Arkansas Nuclear One - Unit 2

CEN-157(A)-NP

Response to Questions
on Documents Supporting
The ANO-2 Cycle 2
License Submittal

July 1981

Figure S-1

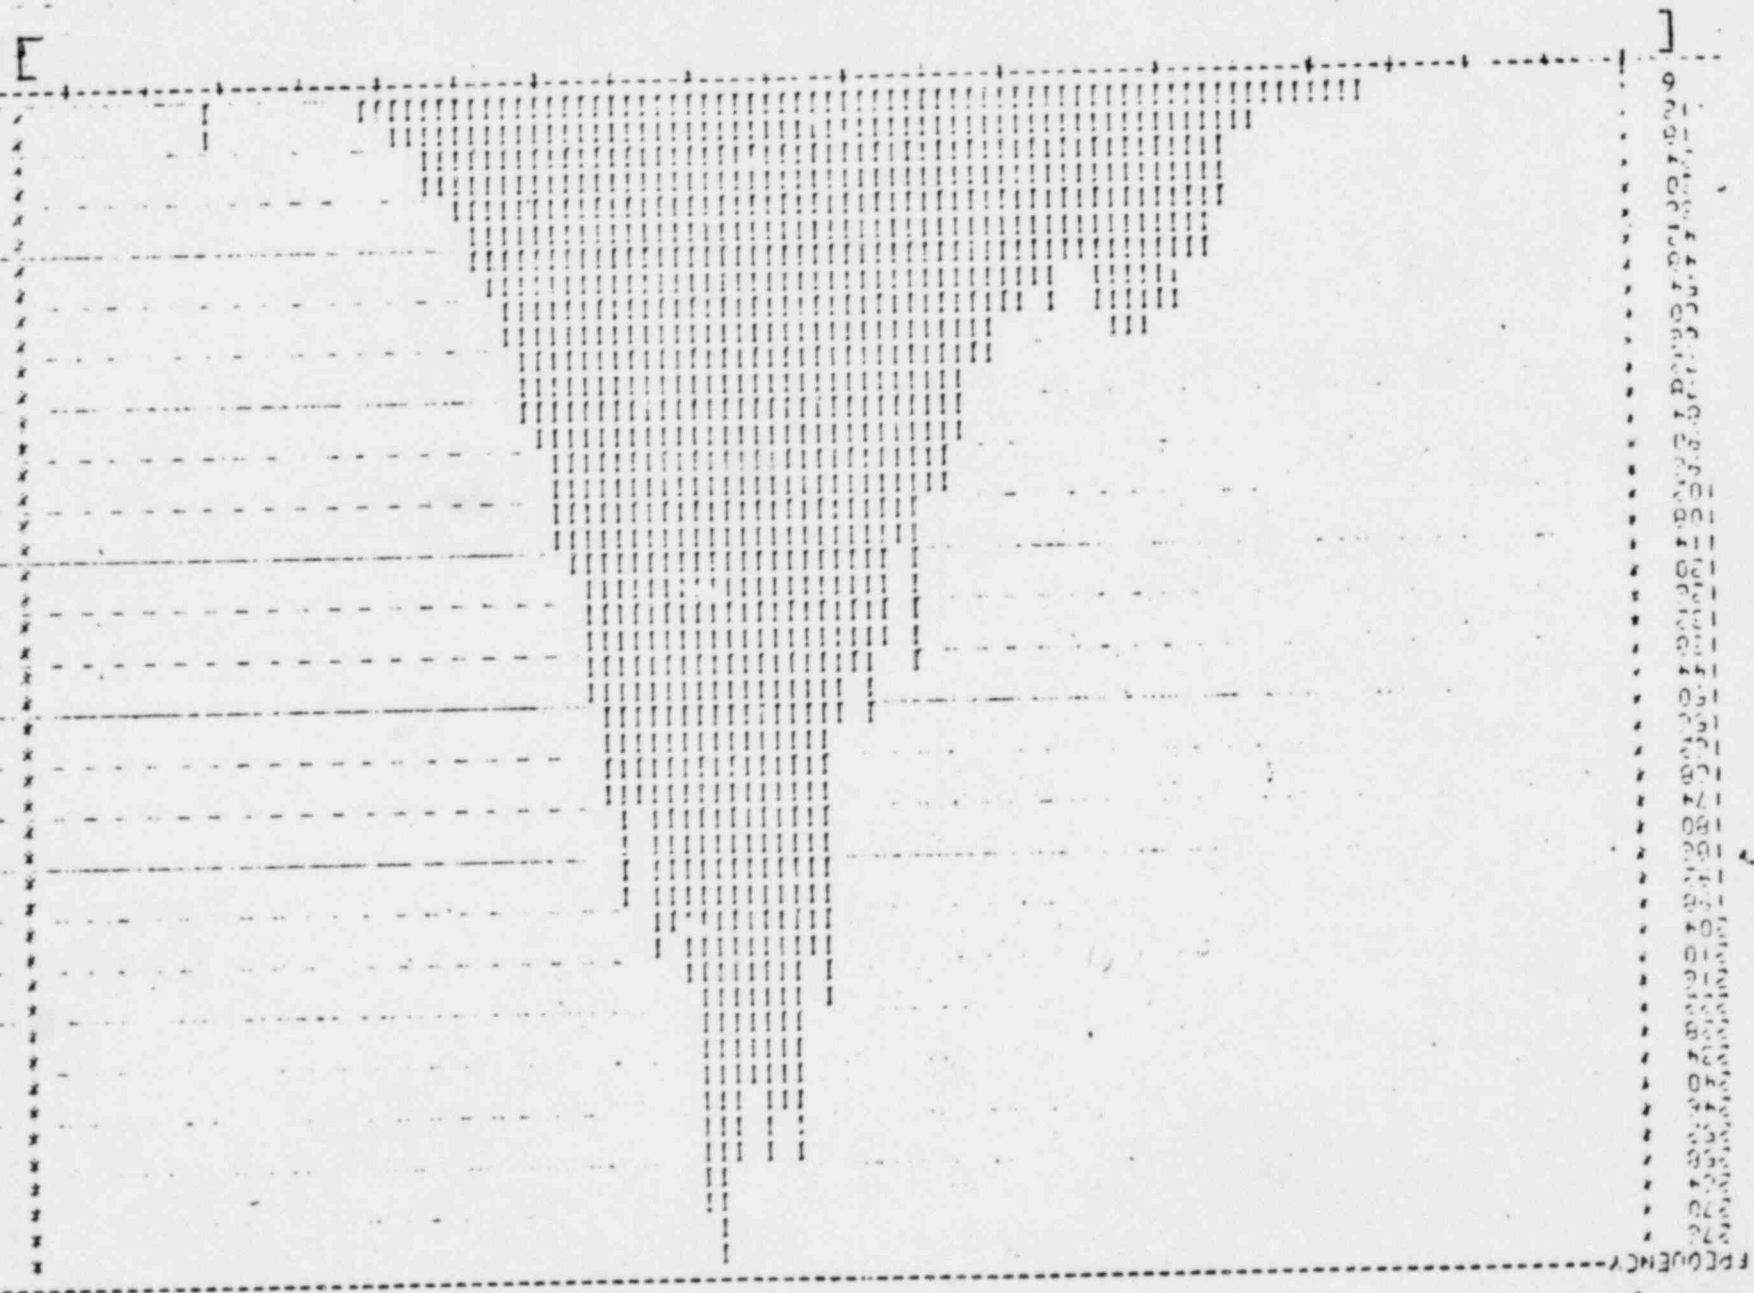
How is the value of power uncertainty factor of [] obtained for DNBR calculation?

The value of the algorithm uncertainty factor (E) in CEN-143(A)-P has been changed. The new value which is installed in the CPC software is []. The value of [] is the 95/95 one sided tolerance factor determined from the distribution of the ratio of CETOP-2 to CETOP-D overpower margins (see Figure S-1). The change in the E value is due to the following reason:

The CETOP2 code is written to use the hot channel peaking factor (hot channel power/core average power) as input. In the original analysis this input was used and the CETOP2 vs. CETOP-D analysis yielded a 95/95 tolerance factor of []. During a quality assurance review of the CPC module interfaces it was discovered that the CPC power algorithm calculates a [] peaking factor, rather than the [] peaking factor, for use in the static DNBR calculation. The [] peaking factor is [] than the [] peaking factor.

This input discrepancy was discovered late in the software design process and therefore an algorithm change to correct the discrepancy was not feasible. Instead, the uncertainty assessment was repeated for CETOP2 with the input changed to [] to be consistent with the input to the on-line algorithm. The result of the new analysis was that the error distribution shifted by almost []. The new value of [] reflects the actual CETOP-2 on-line algorithm performance relative to CETOP-D.

The value for E in the CPC data base for ANO-2 Cycle 2 is []. However, the CETOP2 to CETOP-D [] This error distribution was [included in the []
